APPLICATION NO.	FILING DATE	FIRST NAMED INVENTOR	ATTORNEY DOCKET NO.	CONFIRMATION NO.
10/813,924	03/31/2004	Byeong-Jun Lee	AIP3.001AUS	5060

Office Action Summary

DETAILED ACTION

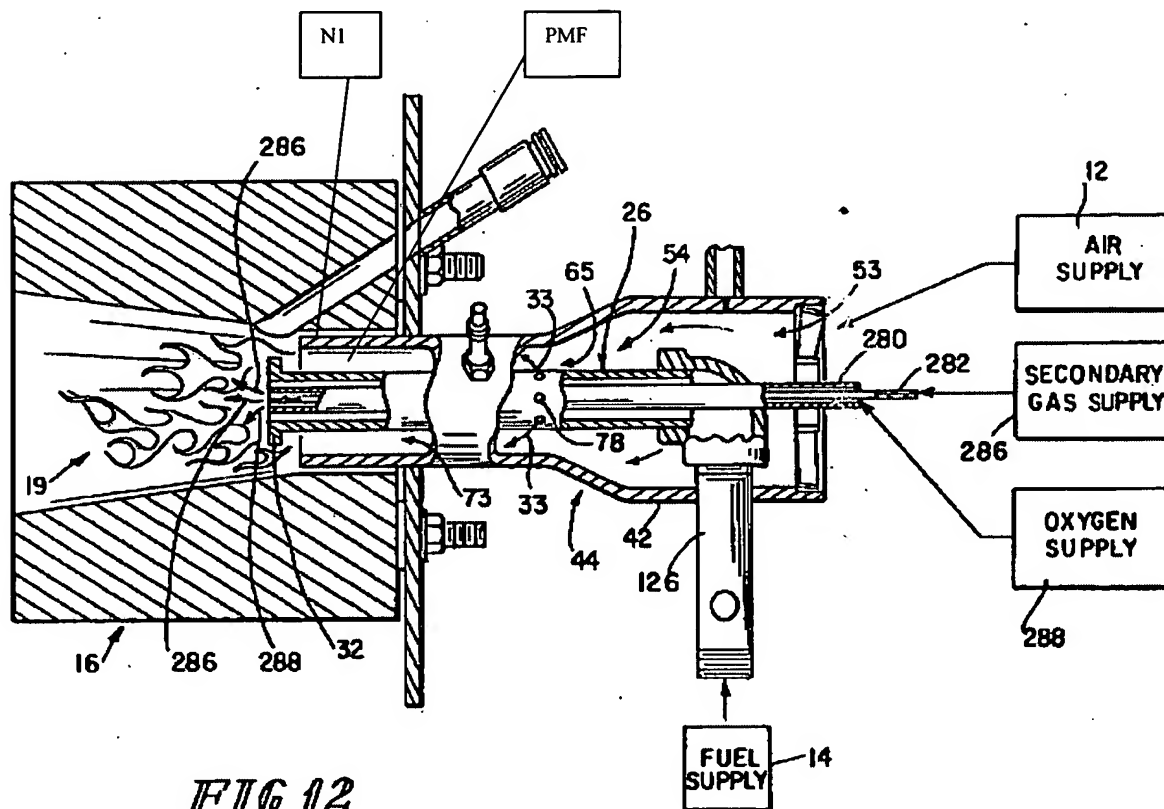
With respect to claim 1, **Cummings** teaches a method of combustion, comprising: supplying a premixed fuel PMF through at least one nozzle N1 into a combustion chamber, the premixed fuel comprising an oxidizer 12; supplying a non-premixed fuel 286 through at least one nozzle 282 into the combustion chamber; and simultaneously burning the premixed and non-premixed fuel in the combustion chamber. See particularly **Figure 12** of Cummings.

With respect to claim 3, **Cummings** teaches that the premixed fuel PMF is a mixture comprising an oxidizer 12 and at least one combustible material 14. See particularly **Figure 12** of Cummings.

With respect to claim 4, **Cummings** teaches that the non-premixed fuel comprises at least one combustible material 286. See particularly **Figure 12** of Cummings.

With respect to claim 5, **Cummings** teaches that the method further comprises supplying an oxidizer 288 substantially free of a combustible material through at least one nozzle 280 into the chamber. See particularly **Figure 12** of Cummings.

With respect to claim 15, **Cummings** teaches that the at least one nozzle N1 for the premixed fuel and the at least one nozzle 282 for the non-premixed fuel 286 are formed in a single piece fuel injector. See particularly **Figure 12** of Cummings.

FIG. 2

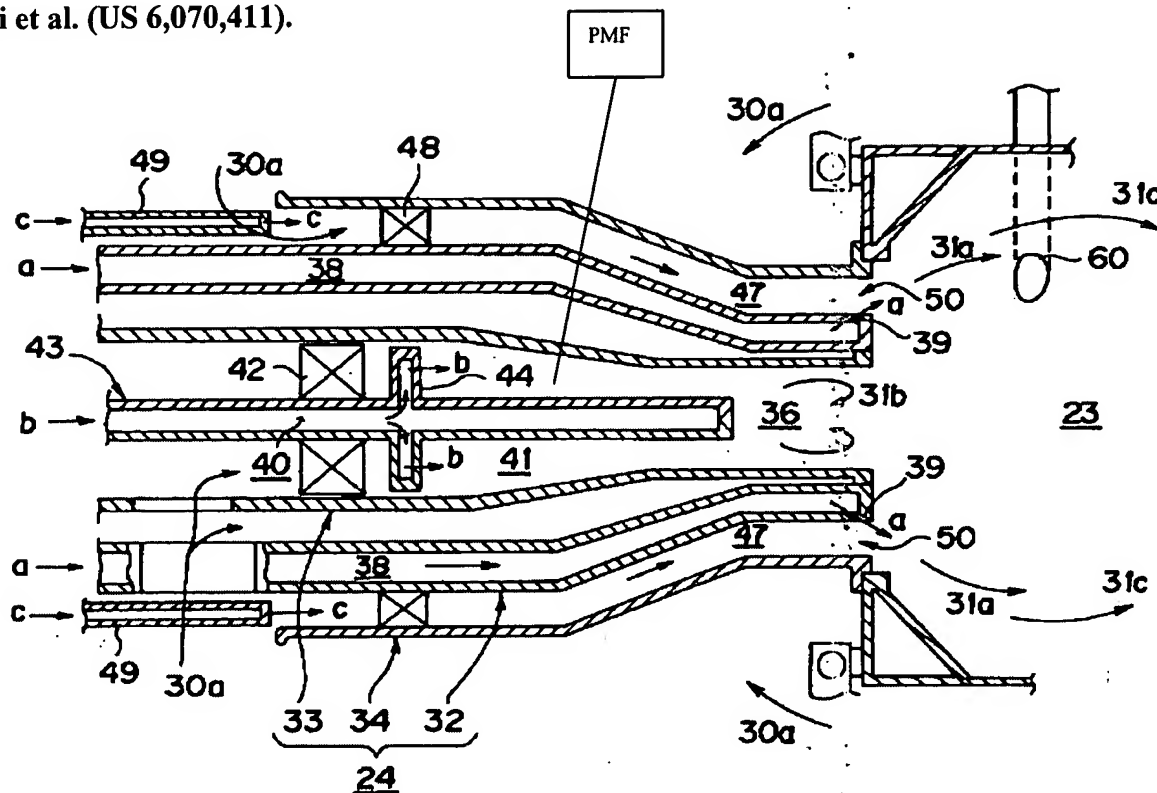
With respect to claim 1, Iwai teaches a method of combustion, comprising: supplying a premixed fuel PMF through at least one nozzle 33 into a combustion chamber, the premixed fuel comprising an oxidizer; supplying a non-premixed fuel A through at least one nozzle 32 into the combustion chamber; and simultaneously burning the premixed and non-premixed fuel in the combustion chamber. See particularly Figure 2 of Iwai.

With respect to claim 3, **Iwai** teaches that the premixed fuel PMF is a mixture comprising an oxidizer and at least one combustible material. See particularly column 9 lines 59; and **Figure 2** of **Iwai**.

With respect to claim 4, **Iwai** teaches that the non-premixed fuel A comprises at least one combustible material. See particularly column 9 line 45; and **Figure 2** of **Iwai**.

With respect to claim 15, **Iwai** teaches that the at least one nozzle 33 for the premixed fuel and the at least one nozzle 32 for the non-premixed fuel are formed in a single piece fuel injector 24. See particularly **Figure 2** of **Iwai**.

FIG. 1

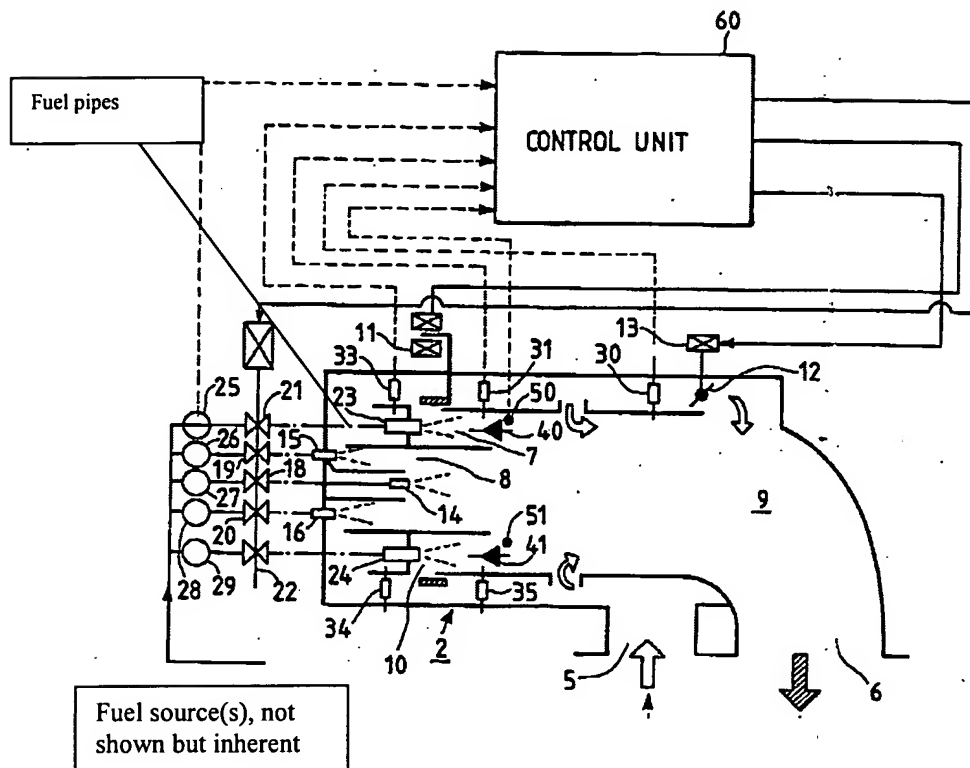
With respect to claim 17, **Ohyama** teaches a burner, comprising: a combustion chamber 2; at least one premixed fuel nozzle 23 configured to supply a premixed fuel into the chamber, at least one non-premixed fuel nozzle 14 configured to supply a non-premixed fuel into the chamber; at least one premixed fuel pipe (shown but not labeled) connecting the at least one premixed fuel nozzle 23 with a premixed fuel source (not shown but inherent); at least one non-premixed fuel pipe (shown but not labeled) connecting the at least one non-premixed fuel nozzle 14 with a non-premixed fuel source (not shown but inherent), and a controller 60 to control operation of the burner, wherein the controller is configured to operate the burner in one or more

modes, in which the premixed fuel is supplied to the chamber through the at least one premixed fuel nozzle 23 and the non- premixed fuel is supplied to the chamber through the at least one non-premixed fuel nozzle 14. See particularly **Figure 1** of Ohyama.

With respect to claim 19, **Ohyama** teaches that the burner comprises a plurality of premixed fuel nozzles (23, 24), and wherein the plurality of premixed fuel nozzles are arranged so as to surround the at least one non-premixed fuel nozzle 14. See particularly **Figure 1** of Ohyama.

With respect to claim 20, **Ohyama** teaches that at least a portion of the plurality of premixed fuel nozzles (23, 24) is located on an imaginary circle (not shown but inherent since it is a typical arrangement used in the art) surrounding the at least one non-premixed fuel nozzle 14. See particularly **Figure 1** of Ohyama.

With respect to claim 21, **Ohyama** teaches that the at least one non-premixed fuel nozzle 14 is located on the center of the imaginary circle. See particularly **Figure 1** of Ohyama.
